RESPONSE TO REQUEST FOR ADDITIONAL INFORMATION

APR1400 Design Certification

RAI No.: 493-8621
SRP Section: 09.02.01 - Station Service Water System
Application Section: 9.2.1
Date of RAI Issue: 05/31/2016

Question No. 09.02.01-9

Figure 9.2.1-1 Essential Service Water System Flow Diagram

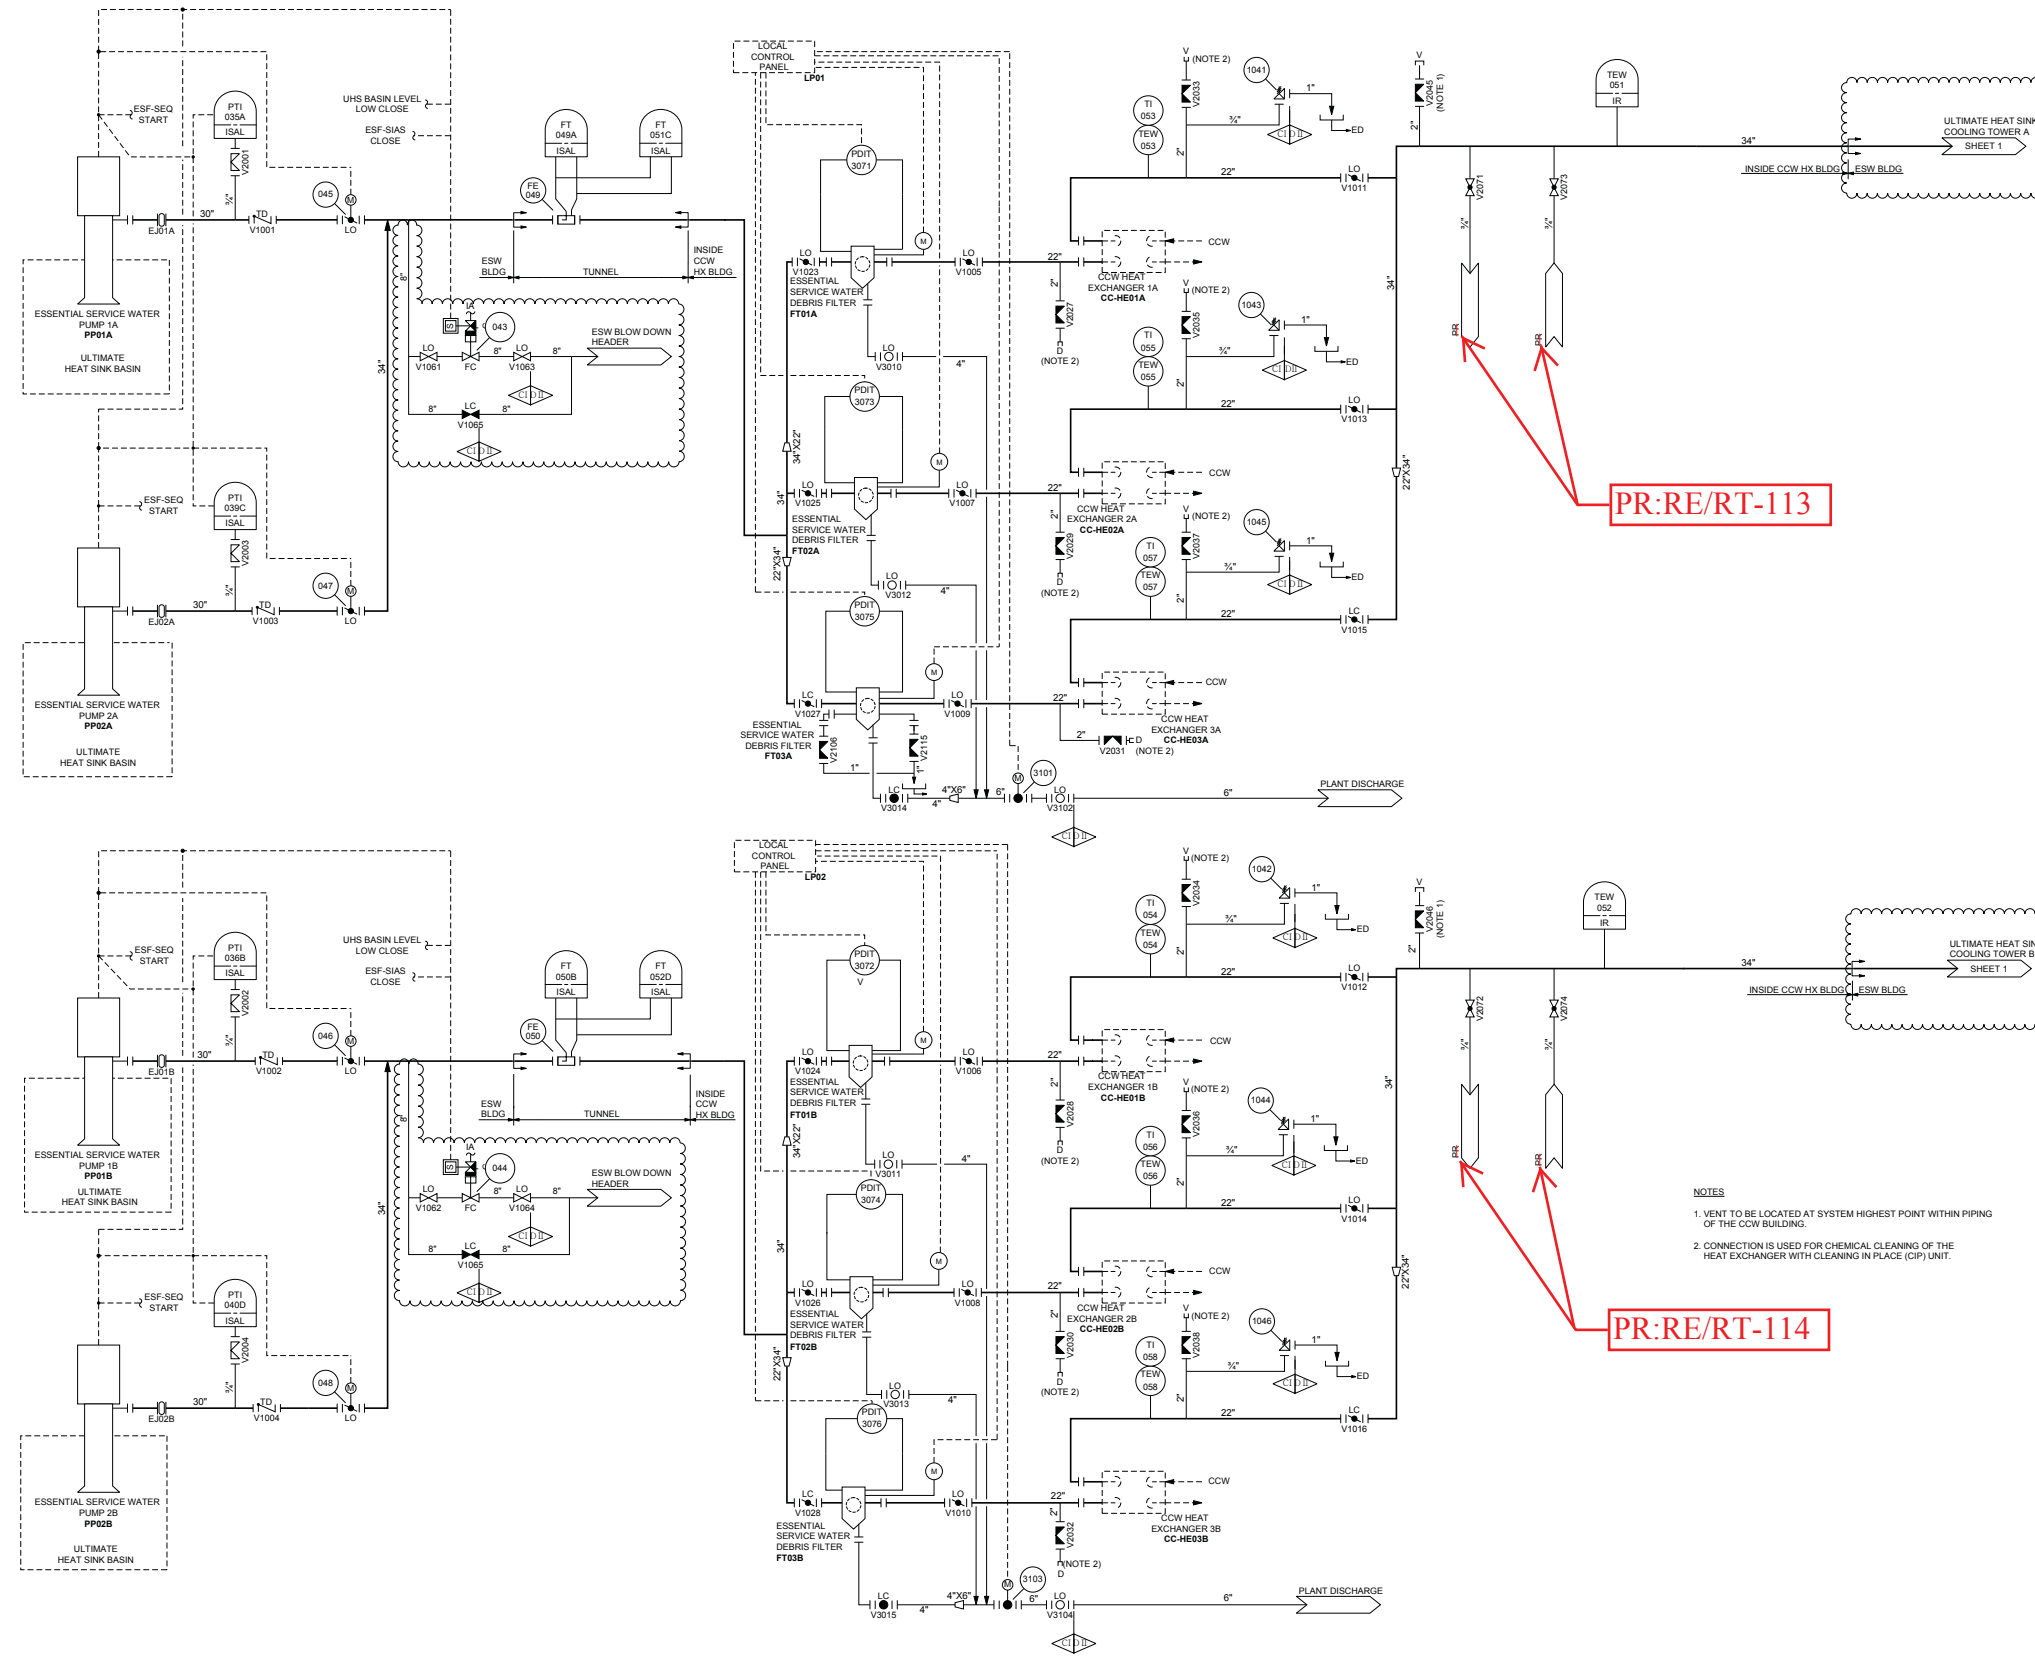
The NRC staff reviewed the response and determined it is incomplete. SRP Section 9.2.1 Subsection III.3.D asks that the ESWS system piping and instrumentation diagrams (P&IDs) show radiation monitors located on the system discharge and at components susceptible to leakage, and these components can be isolated by one automatic and one manual valve in series. The staff reviewed the P&ID of Figure 9.2.1-1 and the RAI response, and could not find the above information. The applicant is requested to provide the isolation valve information and radiation monitors in the P&ID in accordance with the SRP guidance.

Prior to any radiation leakage being detected in the ESWS, radiation alarms on the CCWS side alerts the operators of contamination in the CCWS. The affected CCWS division is immediately isolated followed by the isolation valves (V1005 ~ V1016) on the inlet and outlet lines of the CCW heat exchanger cold side (ESW) to prevent possible contamination of the UHS and the environment.

PR of Figure 9.2.1-1 in DCD Tier 2 will be corrected to PR: RE/RT-113, 114 in accordance with Figure 11.5-1.

Figure 9.2.1-1 of DCD Tier 2 will be revised as indicated in Attachment.
